RE: Development Variance Application for 7665 Cerulean Drive, Pemberton BC

Re: DVP 127-7665 Cerulean Dr.

Photos: # 7665 taken from central area of # 7663. Note that the retaining wall obstructs the view of peak and valley in the background.

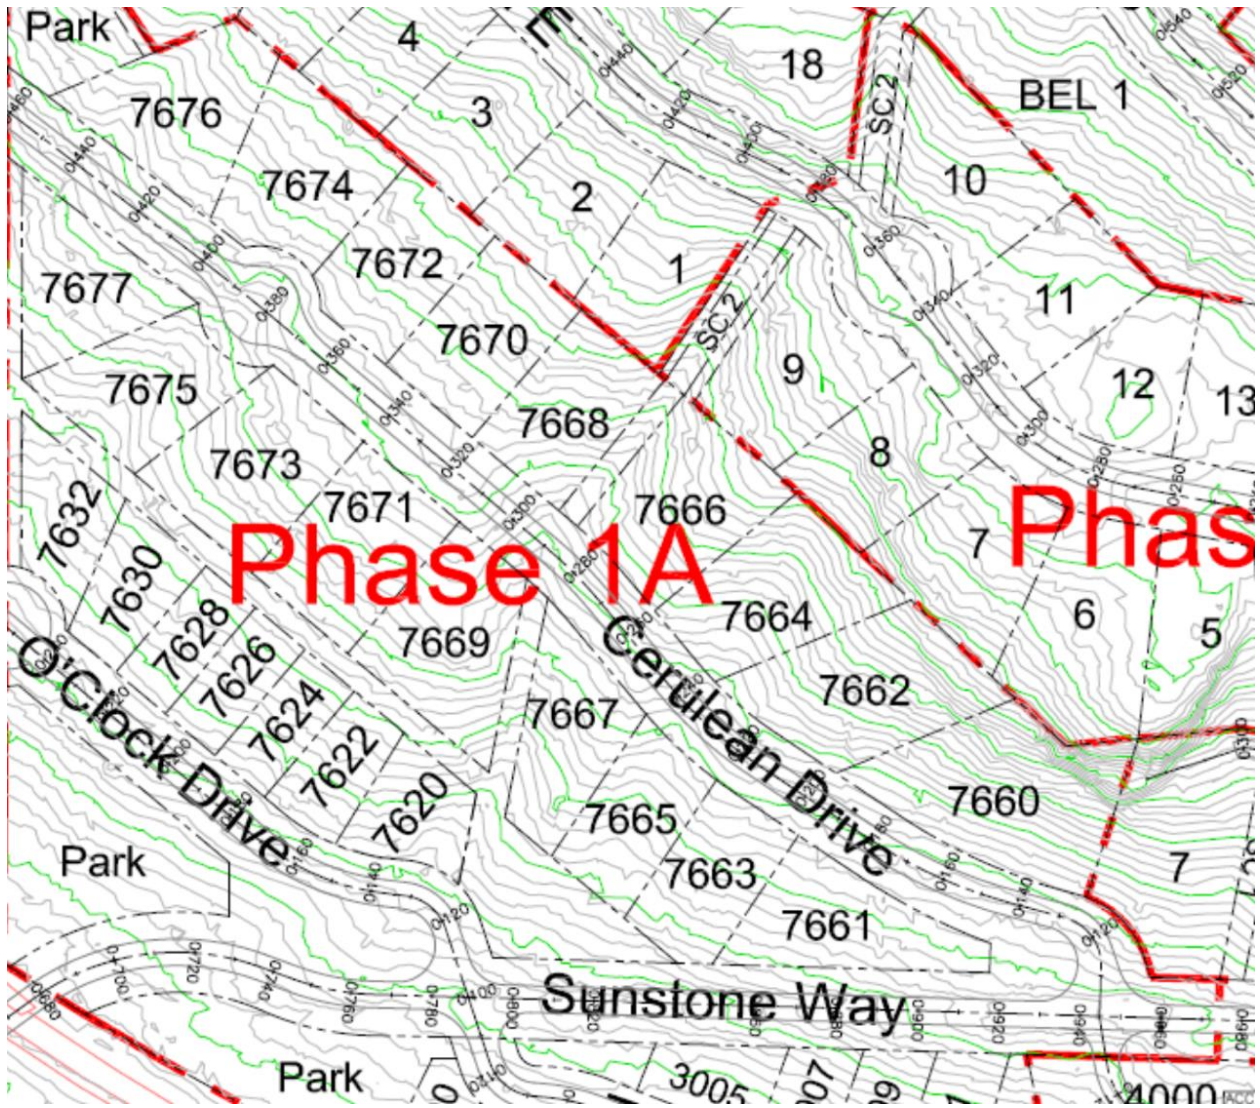
I have previously provided documentation and photos showing the size of the retaining wall and the impact it has on adjacent lots – it is simply not possible to “fix” the impact through a landscaping plan¹.

¹ The proposed landscaping plan is for three one-gallon Virginia Creeper plants to screen a wall that is 4.3 metres high at its highest. Please refer to the photos on the next page.

ATTACHMENT 4

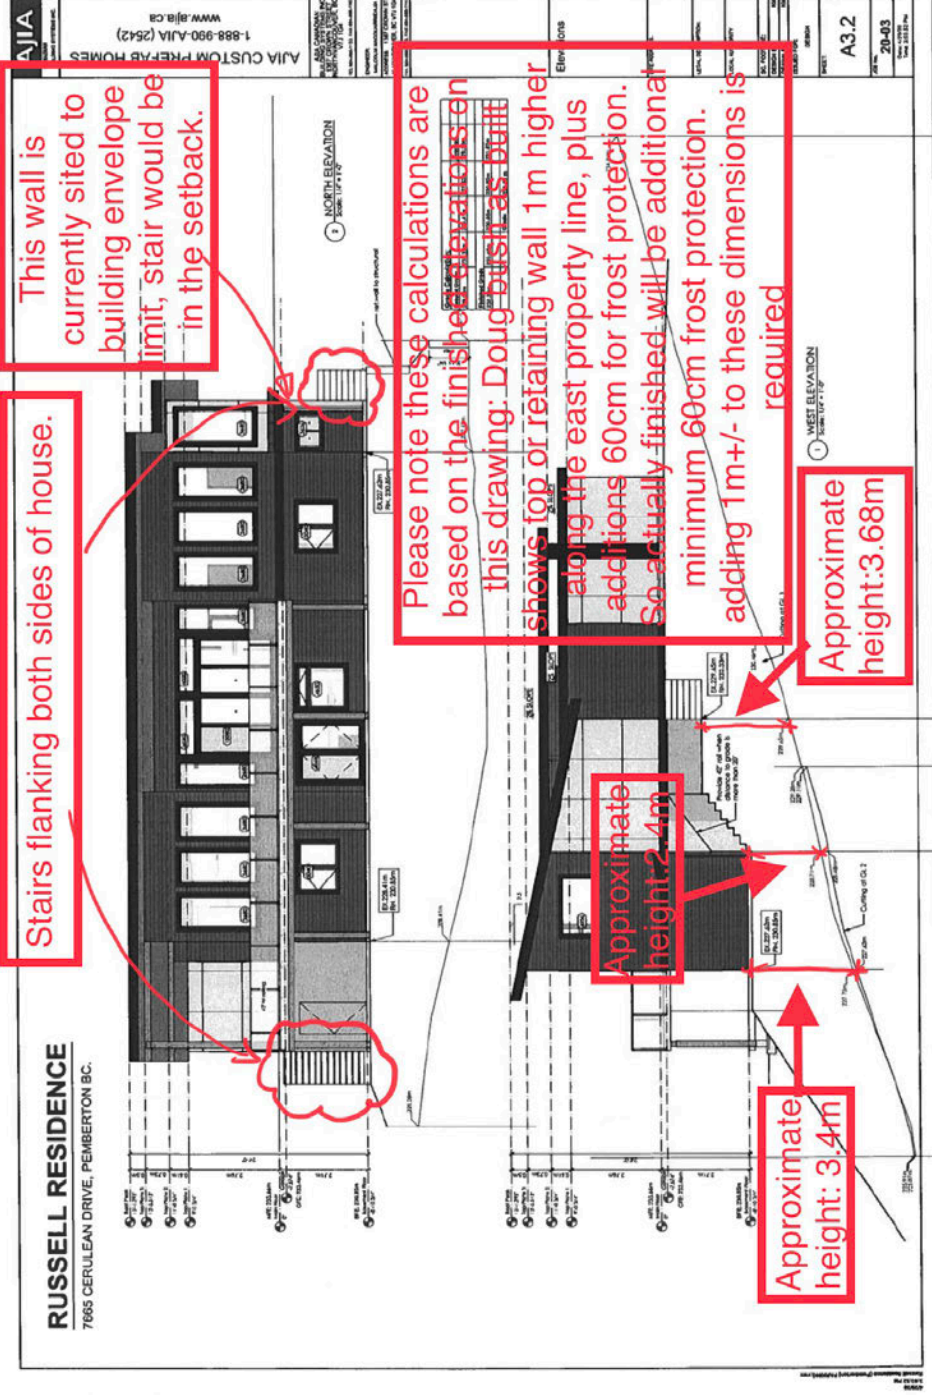
ACCESS STAIR IN SET BACK In reference to the applicants drawing A3.2 North Elevation of the architectural drawings please see ATTACHMENT 4, which shows the stairs flanking the house. Based on Doug Bush survey File no (J20168) also attached in the DVP application, the proposed foundation is currently located at 1.53 m to the property line. If the stairs are built to code they will project 860mm +/- into the interior side setback.

Village of Pemberton zoning bylaw 832, 2018 4.13- projections into required setback and exception to the siting requirements a (iv): *"Stairs accessing a deck, porch, veranda may be located within a front, exterior side setback or rear, but shall not be located within any interior side setback."*

Therefore the retaining wall should be reconstructed and also the portion of the house along the east property line should be re-designed to avoid stairs utilizing the setback and or avoid an over height retaining wall.

- 8) ADDITIONAL OVER HEIGHT WALLS REQUIRED, further along in the construction process of lot 7665 there will be additional retaining walls required that exceed current bylaw NO 832 2018, please again reference ATTACHMENT 4 west elevation of A3.2. Currently there is backfill material retaining the bottom of the retaining wall, once removed will create a over height retaining wall. Therefore the retaining wall should be reconstructed and the foundation of the house re-designed to better suite the retaining wall and topography and respect the interior side set backs.
